OFFICE OF
FRESNO
IRRIGATION DISTRICT

RE: Review of 30% High Speed Rail Plans for Segment 1A

(Veteran's Boulevard to Stanislaus Street)

FID Facilities: Herndon Canal No. 39 Lisenby No. 45, Victoria No. 42, Victoria Colony No. 43, Tracy No. 44, Cole West Branch No. 40, Cole South Branch No. 40, and Dry Creek No. 75.

CONTRACT NO.
DRAWING NO.
UT-C4019
SCALE
AS SHOWN
SHEET NO.

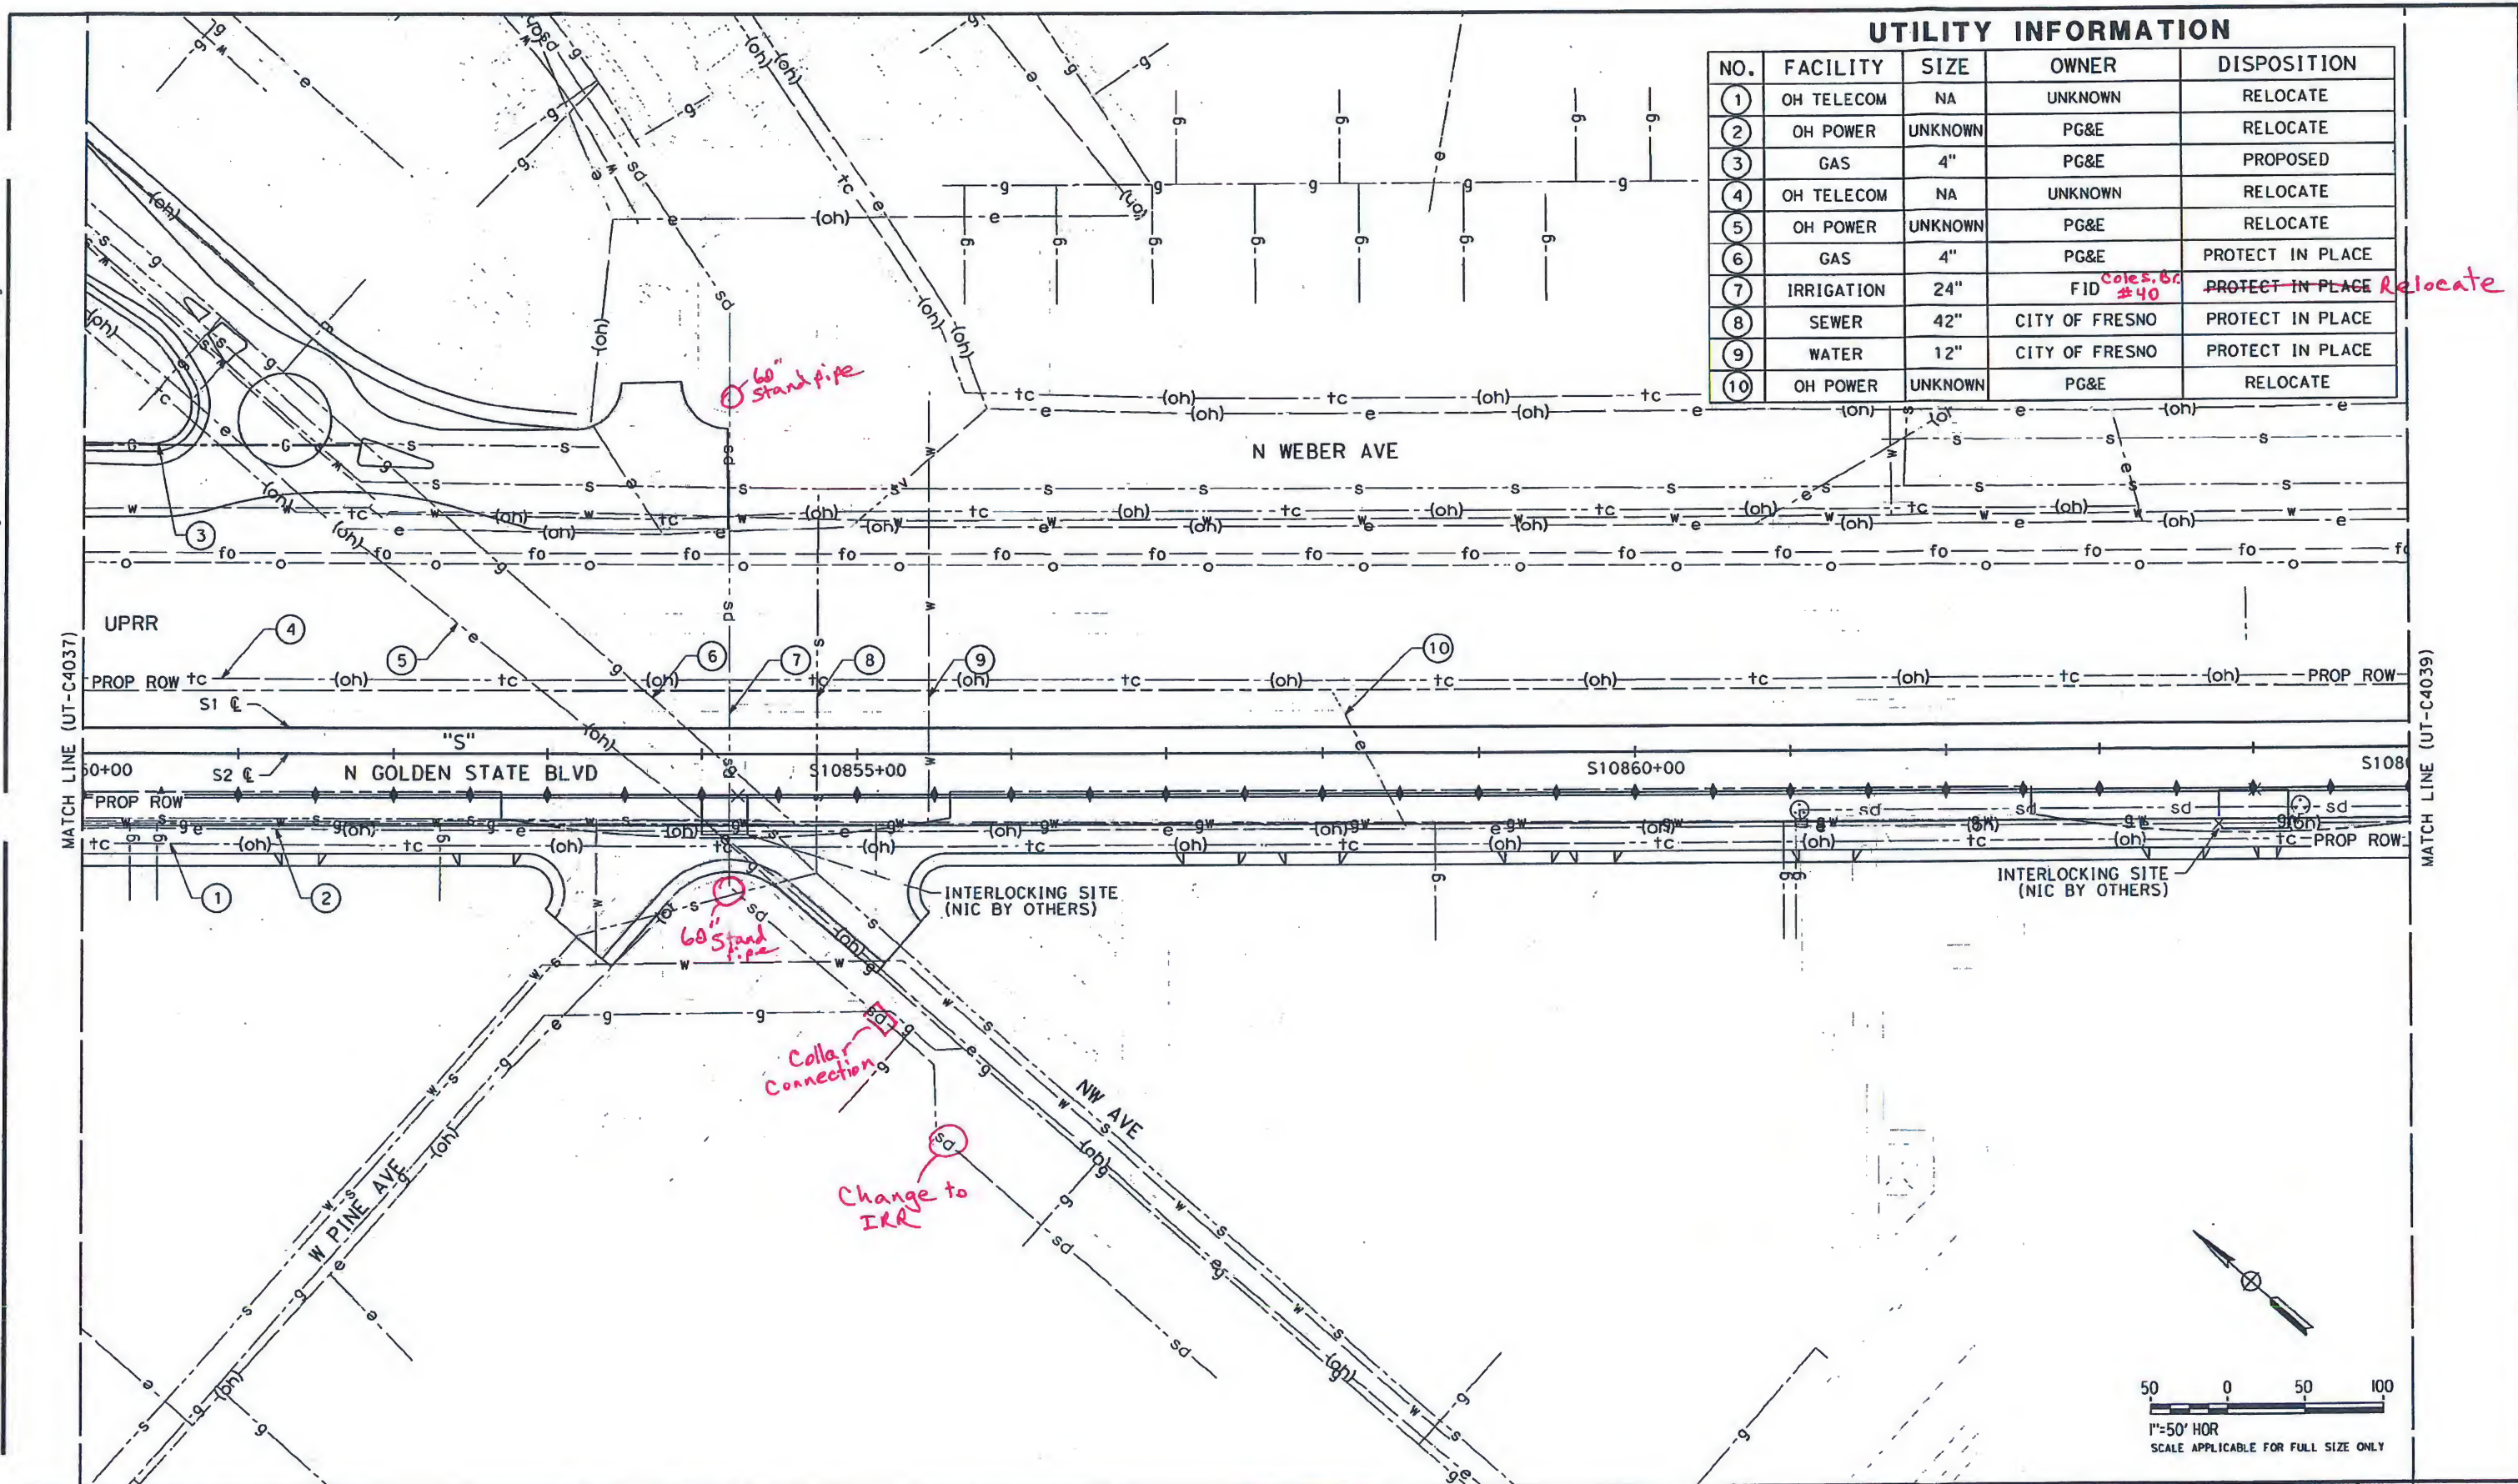
Victoria No. 42, Victoria Colony No. 43, and Tracy No. 44 (HSR, Hwy. 99, Valentine and Dakota avenues)

- Provide a plan/profile along the centerline of FID's facility that shows the limits of the pipeline construction and connection to existing pipeline, and includes location of other utility crossings in plan and profile views.

- New pipeline will be required in all locations that will be within proposed CHSRA, Caltrans or City right of way due to the age of the facilities, non-reinforced pipe and inadequate structural properties to handle additional loading or vibration from the movement of heavy equipment and vehicles during construction. The alignment of these facilities needs to be reconsidered to eliminate angle points under roadways and to allow for any standpipes or box structures to extend above ground.

- The existing box structure on the west side of Highway 99 shall be replaced in accordance with FID standards. A possible relocation is located on a markup provided. A detail for this structure shall be included in the plans. The location of this structure shall be confirmed to be accessible to FID at all times. In addition, this box is a diversion box and headgate structure for both the Victoria Colony No. 43 and the Tracy No. 44 and will therefore require two gates at this location.

- Plans shall include or reference the FID standard concrete collar connection detail where new ASTM C-361 Rubber-Gasketed Reinforced Concrete Pipe (RGRCP) will connect to existing concrete pipe at both the east and west limits of the facility relocation.

- The casing shall extend across the CHSRA's full right of way width. More detail is needed to understand the location of construction/receiving pits and the extent of construction to determine the work within the UPRR right of way. The box structure on the upstream side (within the UPRR right of way) will likely need to be replaced with a 60-inch standpipe or similar structure.

- Add the name of FID's facility to all appropriate plan sheets, including the Utility Information tables on the Utilities sheets.
- Plan sheets reviewed include CV-R1009-R99, CV-G1010-R99, CV-G1009-R99, CV-G1017-R99, CV-G1007, CV-R1017-R99, UT-C4019, UT-C4020, C4033. Please identify any other sheets that cover the area of this FID facility.

CONTRACT NO.
DRAWING NO.
UT-C4038
SCALE
AS SHOWN
SHEET NO.

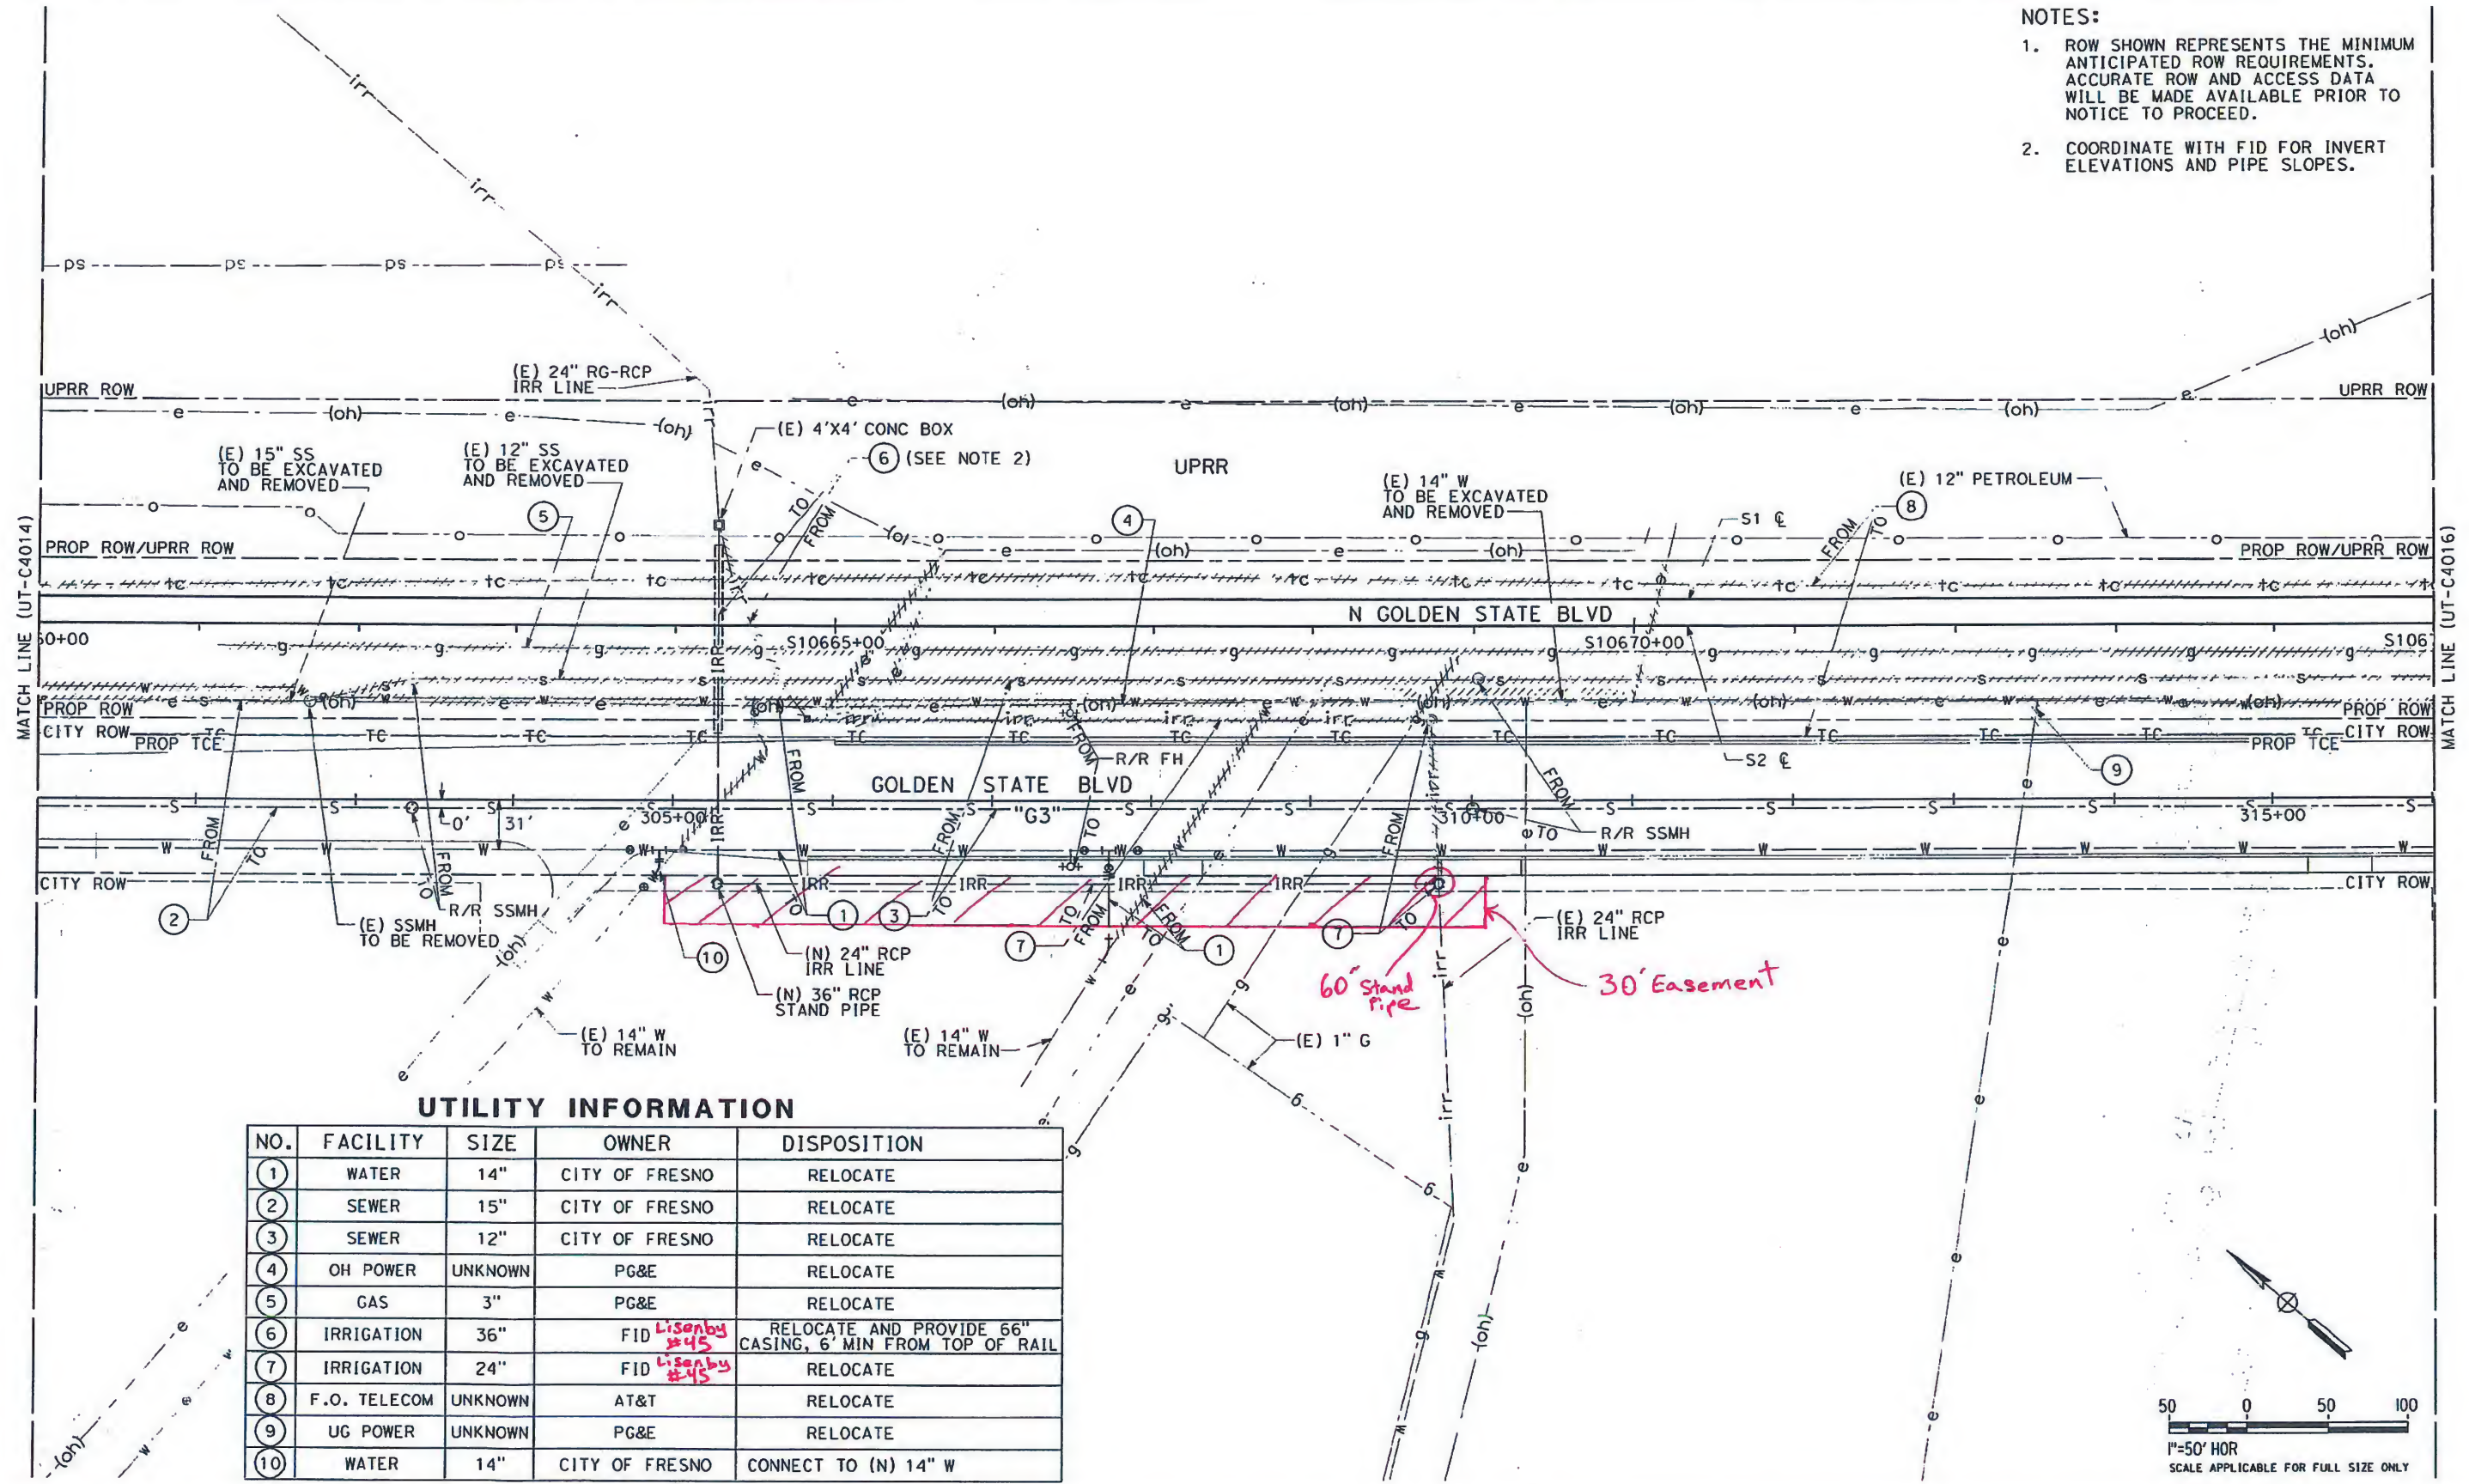
- The existing FID pipeline shall be removed and replaced with new ASTM C-361 RGRCP. The existing pipeline (within and adjacent to CHSRA's right of way) dates back to the 1940s. Protection of pipe is not a suitable solution. It is a non-reinforced concrete pipe and will not handle the additional loading or vibration from the movement of heavy equipment and vehicles during construction.

- Provide a plan/profile along the centerline of FID's facility shows the limits of the pipeline construction and connection to existing pipeline, and include location of other utility crossings in plan and profile views.

- FID's pipeline is misidentified as a storm drain facility. Correct the label (and associated linetype) on sheet UT-C4038 from "SD" to "IRR".
- A 60-inch diameter standpipe shall be constructed on both sides of rights-of-way limits for Golden State Boulevard and the CHSR. The standpipes shall be in accordance with FID standards and include a metal cover and access hatch. A detail of the standpipe shall be included in the plans. Refer to the attached details.

- Plans shall include or reference the FID standard concrete collar connection detail where new ASTM C-361 Rubber-Gasketed Reinforced Concrete Pipe (RGRCP) will connect to existing concrete pipe at both the east and west limits of the facility relocation.

- Add the name of FID's facility to all appropriate plan sheets, including the Utility Information tables on the Utilities sheets.
- Plan sheets reviewed include UT-C4038. Please identify any other sheets that cover the area of this FID facility.
